**Subject: Martis Valley West Parcel Specific Plan draft Environmental Impact Report**

The Friends of the West Shore (FOWS) and the Tahoe Area Sierra Club (TASC) appreciate the opportunity to provide comments regarding the Martis Valley West Specific Plan (MVWPSP) draft Environmental Impact Report (DEIR).

Left: Excerpted image from Exhibit 9-26 in DEIR

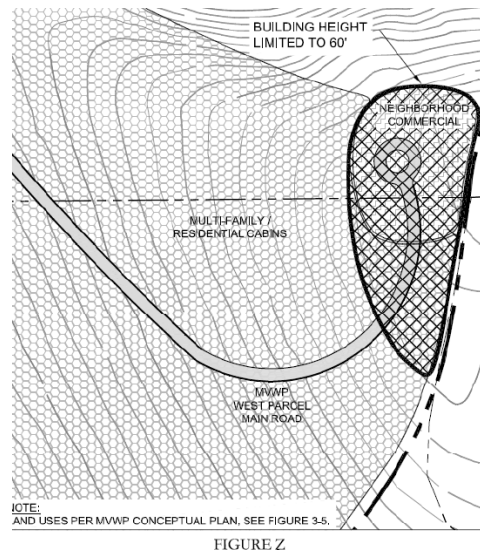
In addition, although the proposed MVWSP identifies a “knoll” whereby new buildings are limited to 60 feet (see below),<sup>118</sup> there are still locations along the ridge where 75’ structures could be built. Although areas may be currently identified for residential development, the DEIR notes that the final building design will be determined later and the proposals examined in the DEIR are only conceptual.<sup>119</sup> Therefore, development of the taller commercial buildings on the highest areas is not precluded by the MVWSP. In addition, once the final project layout is determined (presumably *after* the MVWSP is adopted, and potentially exempt from a full public process and additional environmental review), it may expose other areas on the sloping land from which building forms and light may be seen in the Tahoe Basin.

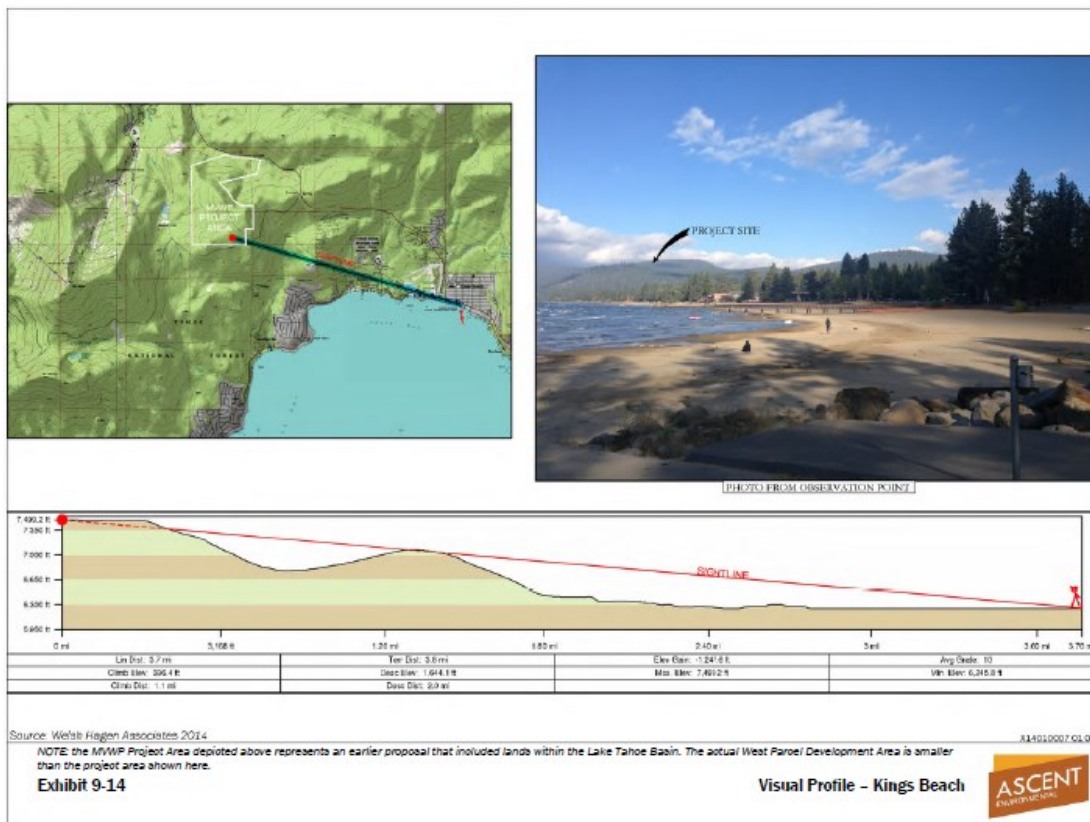
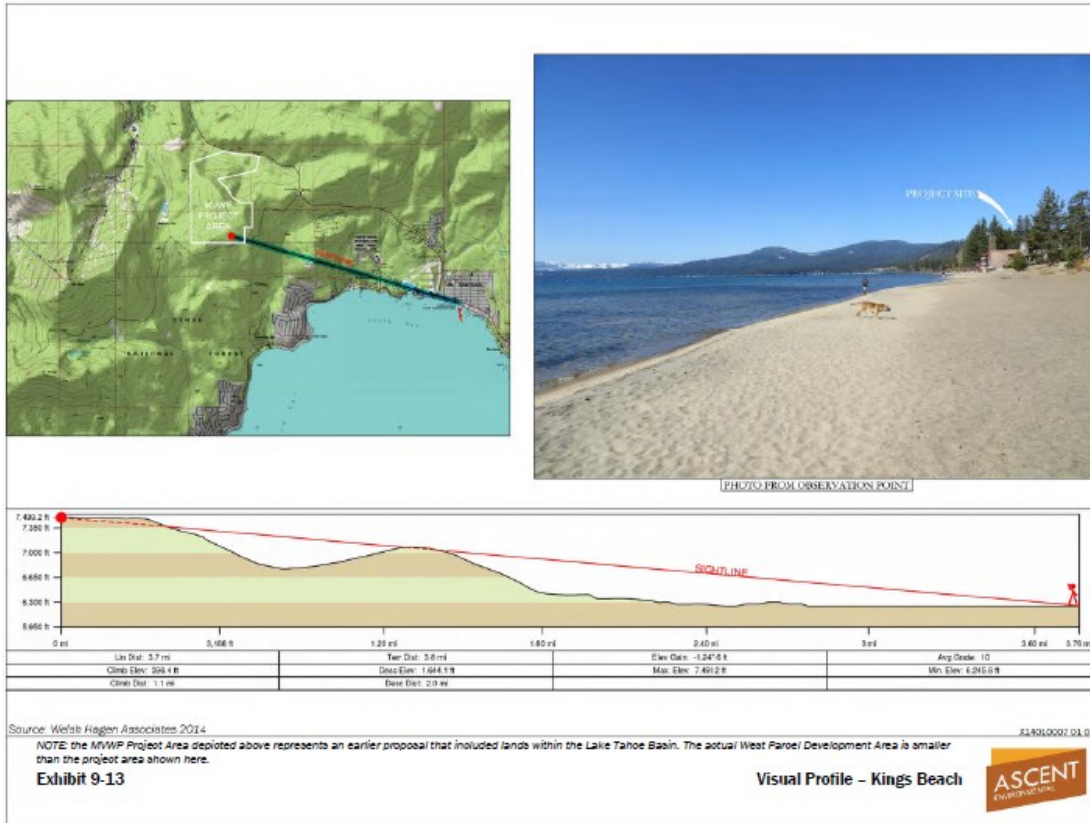
There also appears to be an error associated with Figures 9-13 and 9-14. Although the DEIR states these viewpoints are different and the associated pictures show this, the visual *profiles* for them are exactly the same.

Further, Exhibit 9-14 (also Kings Beach) presumes to begin at the same spot as Exhibit 9-13, but it does not. As the photo clearly shows, the observer in Figure 9-14 is approximately 300 feet to the east of the observer in Figure 9-13, and the

The two photos in Exhibits 9-13 and 9-14 also reveal key observation results that are quite different. The photo in Exhibit 9-13 reveals a ridge line that is apparently so obscure to the viewer that the document preparer was required to add an arrow and a tag - "project site" - to indicate that the ridge was in sight. There is no explanation of the reason for the inclusion of the photo in the document, and there is no explanation of why there are discrepancies in the visual profiles between the two.

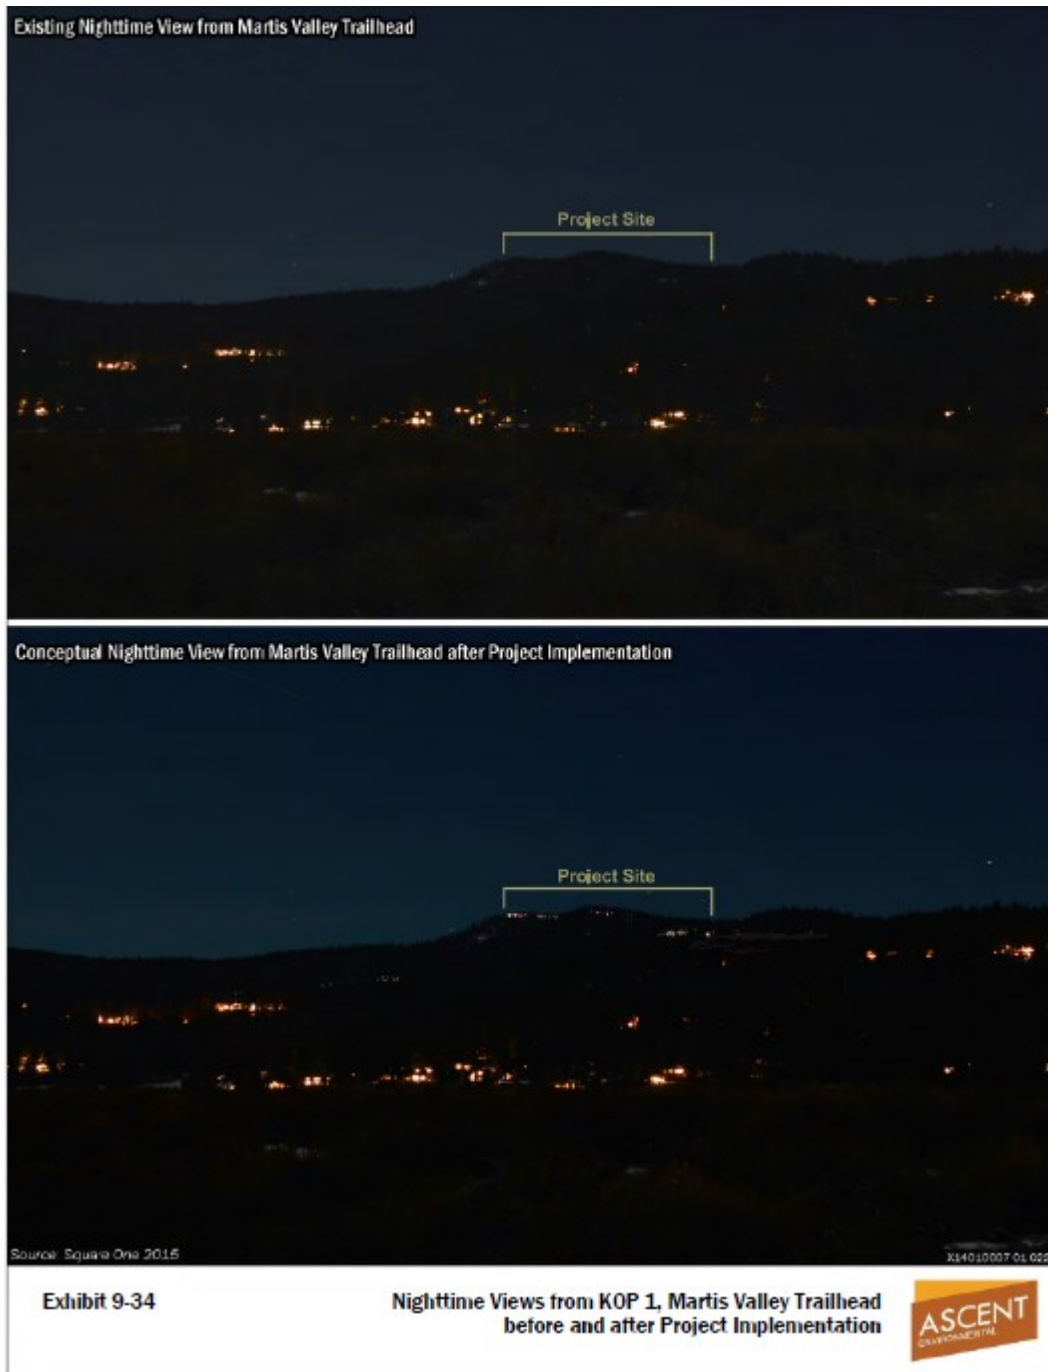
The existing nighttime view from Martis Valley Trailhead shows a ridgeline 100% free of any lighting (Exhibit 9-34, p. 9-49). The proposed project will add lights on the ridgeline<sup>147</sup> (and likely more than simulated in the image,

due to reasons noted in our comments). This is a significant change from the existing condition (no development – meaning no light sources - in this location). It defies logic that the EIR concludes this is less-than-significant and no mitigation is required.<sup>148</sup>
